Docket Number:	23-SB-100
Project Title:	SB 100 Joint Agency Report
TN #:	269276
Document Title:	Clean Air Task Force Comments - Clean Air Task Force - Comments in Response to 2025 SB 100 Joint Agency Report Draft Results
Description:	N/A
Filer:	System
Organization:	Clean Air Task Force
Submitter Role:	Public
Submission Date:	3/20/2026 2:26:35 PM
Docketed Date:	3/20/2026

Clean Air Task Force - Comments in Response to 2025 SB 100 Joint Agency Report Draft Results

RE: Docket No. 23-SB-100 Comments of Clean Air Task Force in Response to 2025 SB 100 Joint Agency Report Draft Results

Figure 1. SB 100 draft results for the baseline scenario, showing the evolution of the CAISO resource mix.

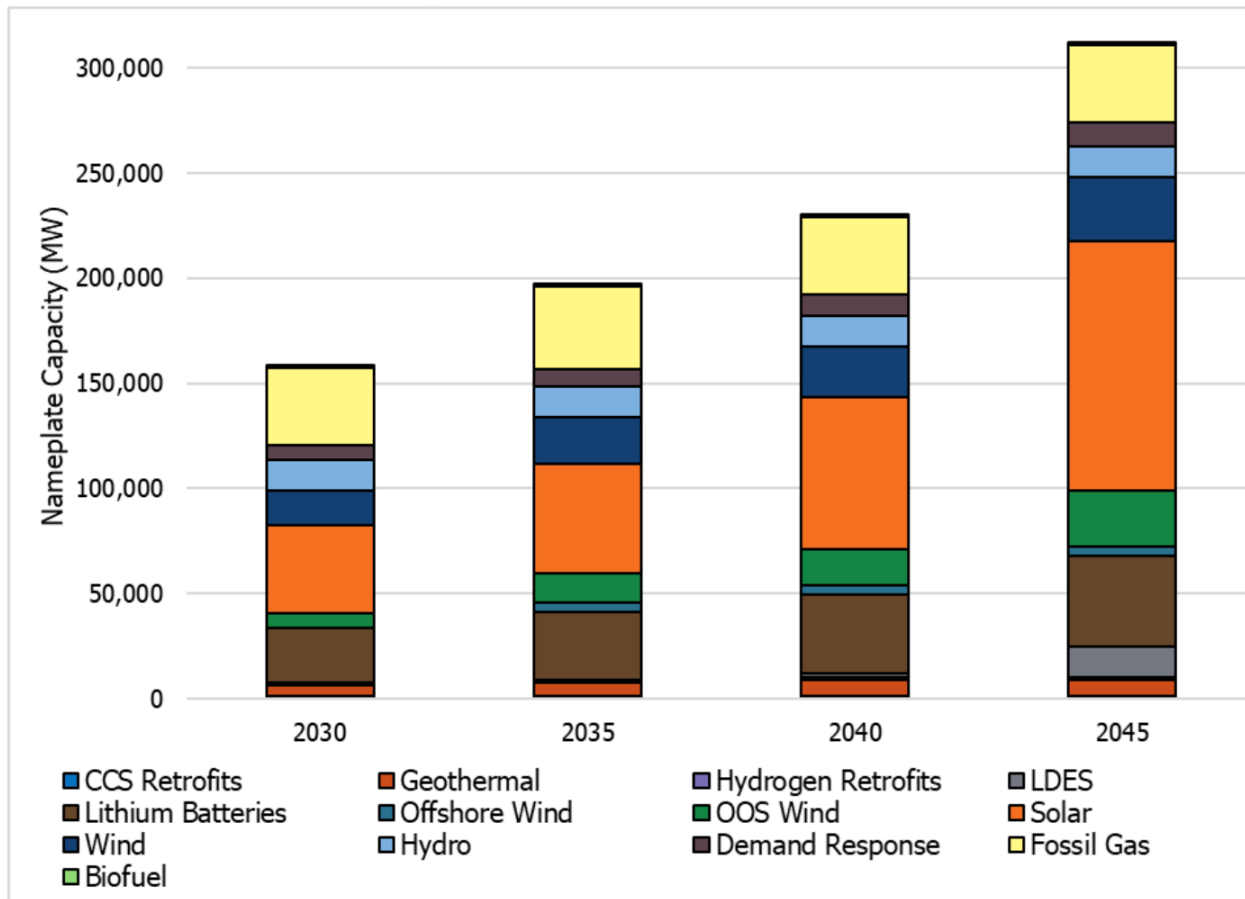
These results do not reflect the latest changes to federal clean energy subsidies under the One Big Beautiful Bill Act.⁹ The loss of federal subsidies for wind and solar projects placed in service after 2027 and phase-out for all clean technologies that begin construction after 2032 will change the competitive landscape of technologies that could contribute to meeting California’s clean electricity goals. While the SB 100 study draft results acknowledge that they do not capture the latest federal policies, they are still rendered less useful to California policymakers unless updated to reflect the current outlook.

Of the scenarios included in the SB 100 report draft results, the “15 GW Carbon Capture” scenario is most reflective of the current policy environment. This scenario assumes that federal tax credits are extended to natural gas with carbon capture and storage (CCS) through 2045,¹⁰ creating a level, universally subsidized playing field across low-carbon technology options that is in some ways similar to the current subsidy-free outlook. In this scenario, 15 GW of gas plants are retrofitted with CCS, which reduces system costs by nearly \$5 billion (inclusive of CCS costs) by replacing 75 GW of the most expensive and least frequently utilized solar, wind, and storage resources. The inclusion of 15 GW of gas with CCS also reduces the required buildout of new resources to achieve climate targets by 4 GW/yr.
